Subject: Further Consultation request - KC Waste Strategy 2025/91147 - Geroge Hotel, St George's Square, Huddersfield
Attachments: DC_2025-91147_Supp Info - Site Waste Management Strategy_0002.pdf

Subject: George Hotel, Huddersfield (2025/91147 and 2025/91148) - Waste Collection Calculation

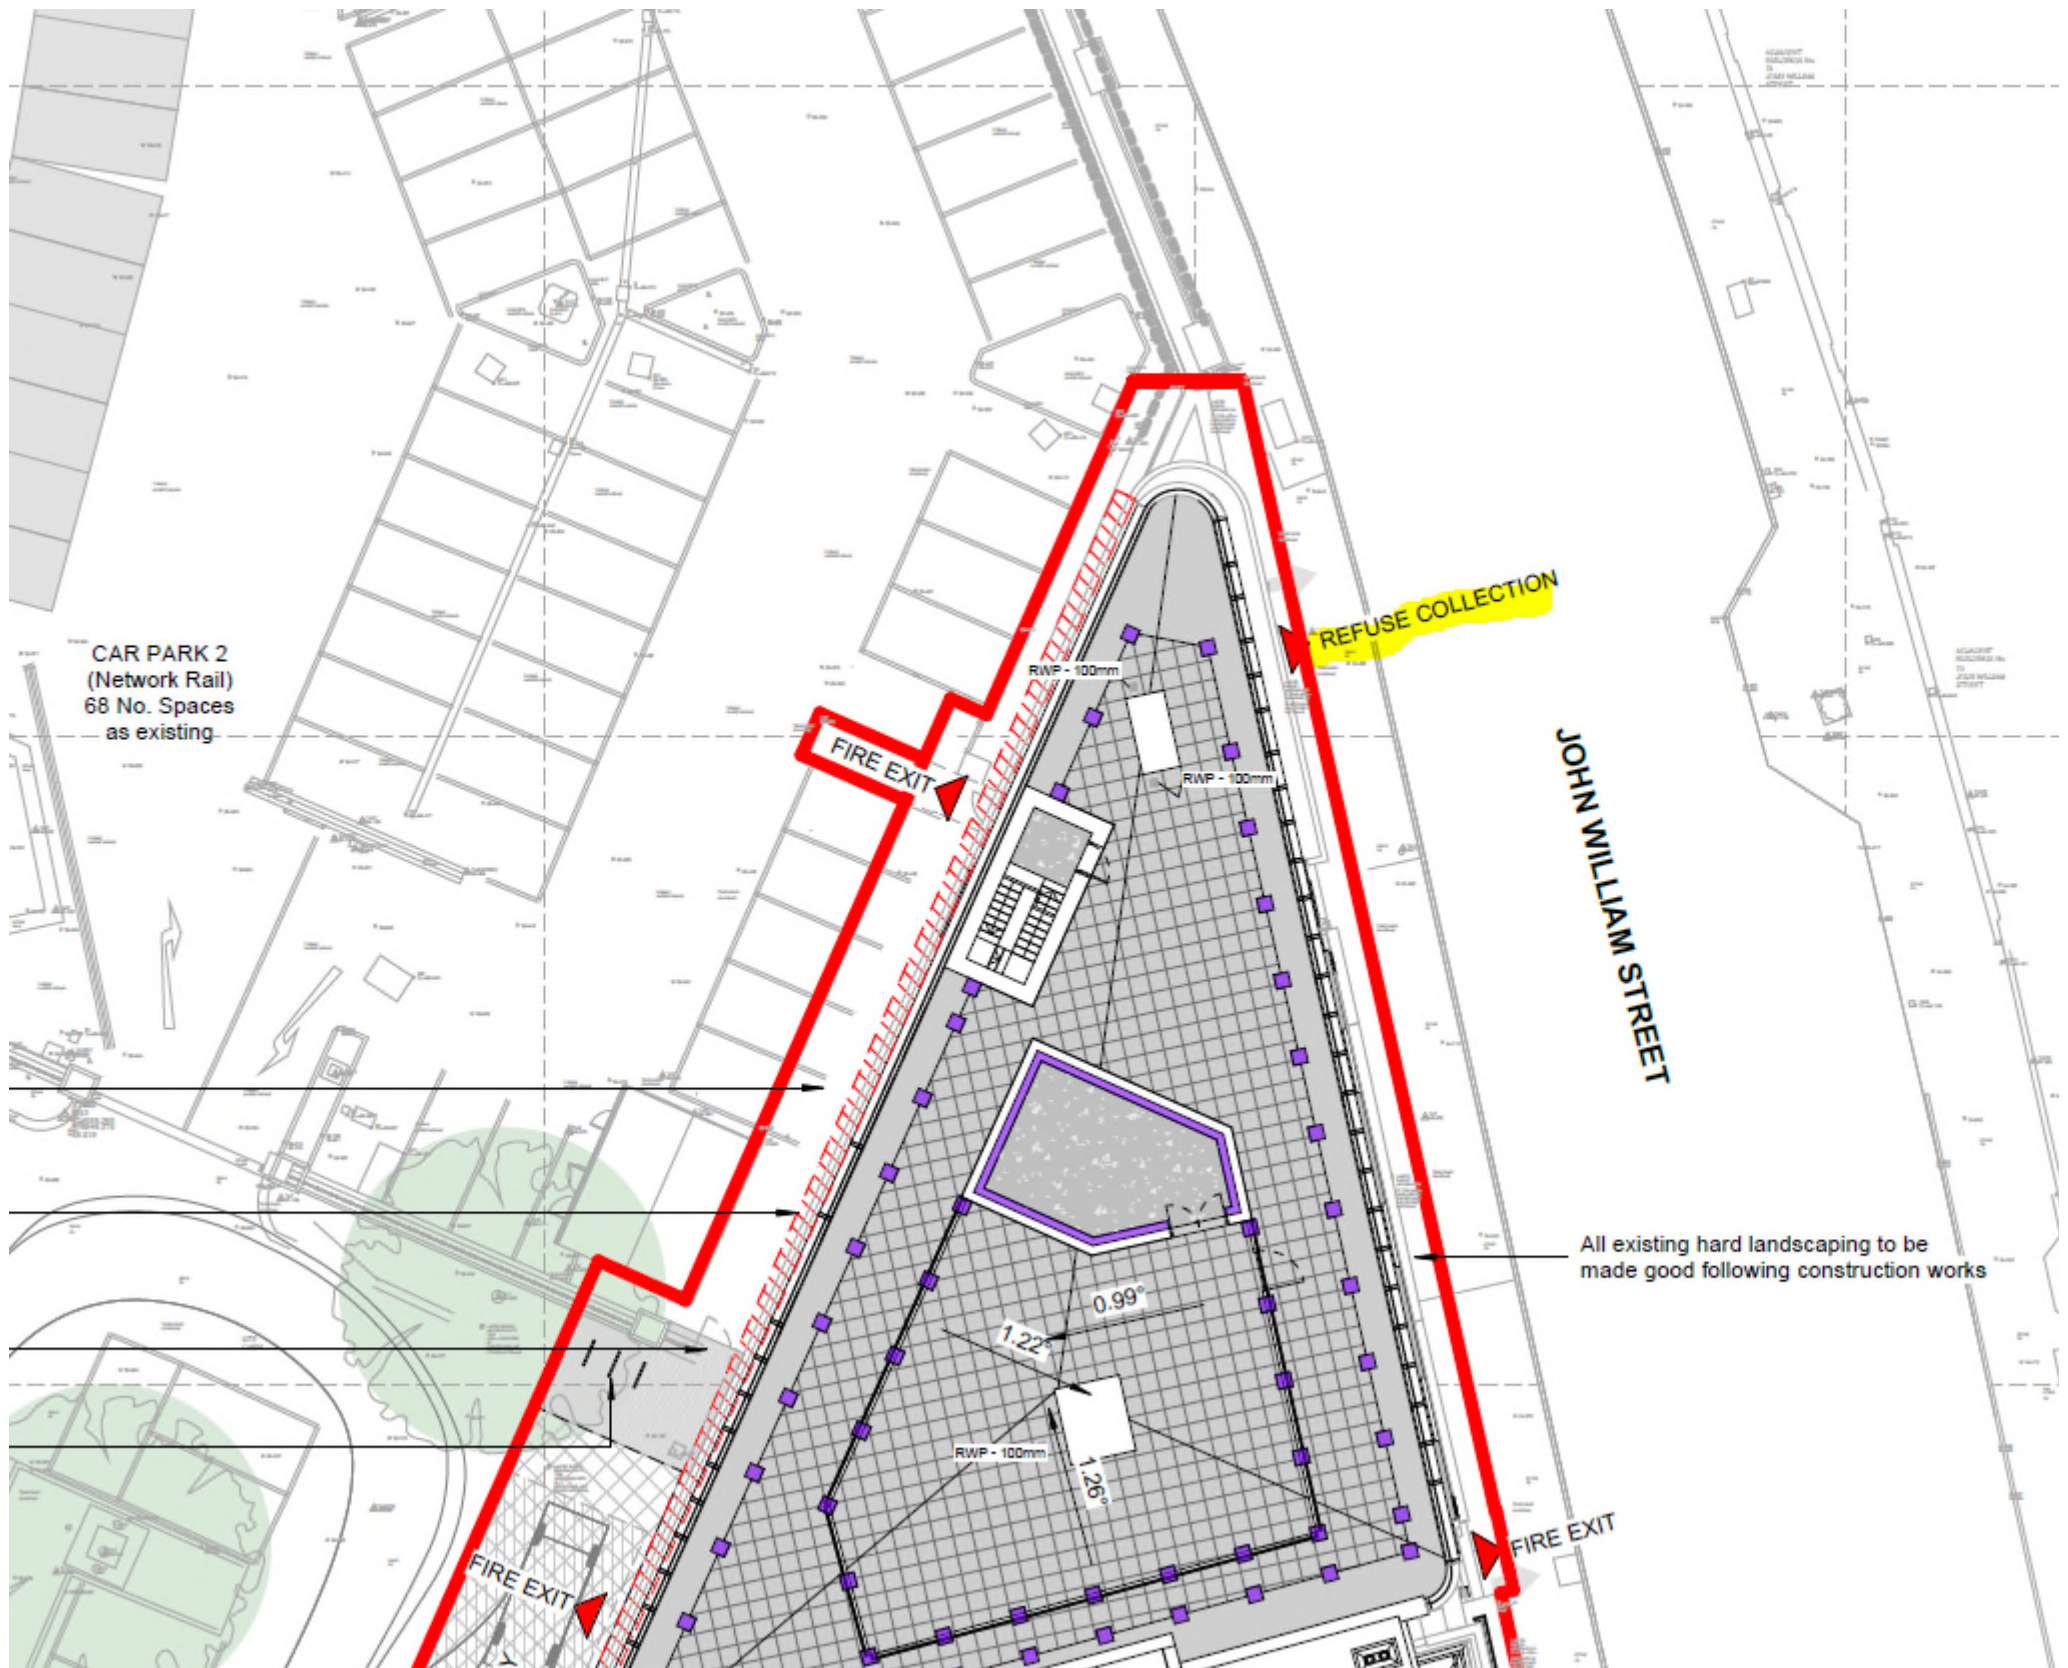
The design team have located the bin store at Ground Floor level on John William Street at the furthest North of the site so as the present the minimum risk of vehicular impact on collection and due to site and footprint restrictions propose the use of compaction with the following proposal/ commitment:

- The initial brief area supplied from the operator Raddison Red (Stage 1 Design Brief) was 12sqm.
- We have used BS 5906:2005 - Waste management in buildings — Code of practice to develop the below calculation.
- The George Hotel shall be targeted as a 4-star hotel with lower levels of recreational, meeting and conference space – therefore falls between the 250l for 2/3 star hotels and 350l for 4/5 Star Hotels = 300 litres of waste per room per week.
- Use of a compactor results in a 3:1 reduction in the number of bins.
 - 108 x 300l = 32,400 of waste

- /1280 (1280l Euro Bin) = 25 No. Bins
- /3 (3:1 Ratio for compactor) = 8.4 No. Bins
- Total No. Bins = 8 Bins collected once per week.
- To reduce impact on floor plate limitation (area constraint) This is proposed to be further reduced by increasing the frequency of collection to 3 No. bins Tri-weekly – This works with the briefed area which is the proposed strategy in line with the designs submitted.
- Note: The applicant is aware of new refuse regulations are in the process of being adopted by Kirklees (relating to food waste) which we won't be able to assess until operation and waste projections can be prepared with the operator following confirmation of planning and subsequent engagement with the operator under contract.

- **Waste Volume:** It is proposed that the waste storage and collection zone shall ostensibly be served by 8nr bins (compactor assisted) collected tri-weekly with separate arrangements made specifically in extreme circumstance (event management arrangement).
- **Highway Safety:** The refuse store is to be located at Ground Floor level on John William Street at the furthest North of the site so as the present the minimum risk of vehicular impact on collection.
- **Visual Amenity:** As indicated below, it is proposed that all waste shall be internally stored until collection (staff assisted).

Collection location as indicated below

After reading the revised waste management strategy for the hotel I note that until the hotel is fully opened the amount of waste produced is unknown. The hotel will use a waste compactor to limit the number of waste containers needed. The hotel also is aware of new legislation that will require it to separate out recycling and food waste. To ensure that the hotel can managed the waste generated it is anticipating that the bins will need to be collected up to 3 times per week.

Reviewing the calculations for waste generation and storage I can confirm that the proposal is acceptable to the authority.
